APPLICATION NO.	FILING DATE	FIRST NAMED INVENTOR	ATTORNEY DOCKET NO.	CONFIRMATION NO.
10/771,846	02/03/2004	Olaf Muller	7100-X04-025CIP (NEW)	9733
27317 .FL.EIT KAIN (7590 08/03/200 GIBBONS GUTMAN I	EXAMINER		
21355 EAST DIXIE HIGHWAY SUITE 115 MIAMI, FL 33180			CULBRETH, ERIC D	
			ART UNIT	PAPER NUMBER
			3616	
			MAIL DATE	DELIVERY MODE
			08/03/2007	PAPER

Advisory Action Before the Filing of an Appeal Brief

Application No.	Applicant(s)
10/771,846	MULLER, OLAF
Examiner	Art Unit
Eric Culbreth	3616

Fig. 9

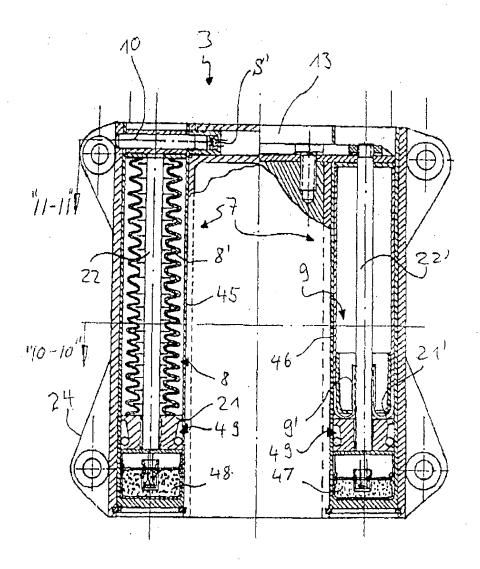
Entry approved &c. 7/31/07

Fig. 10

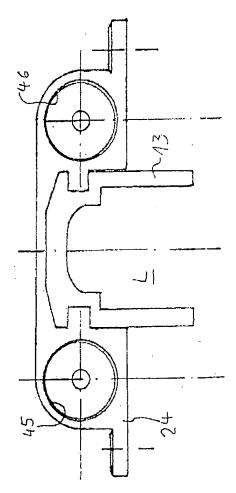
Ety approved EE 7/31/07

Fig. 11

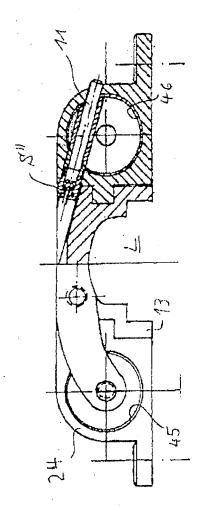
Entry Cyppwred EC 7131507

Fig. 13

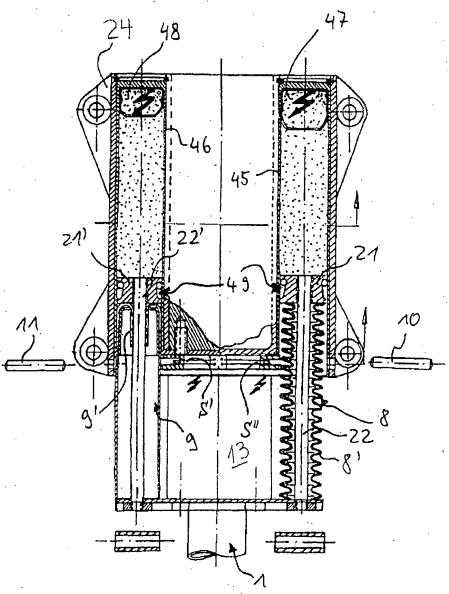
Entry Coppored. Ec 7/31/07
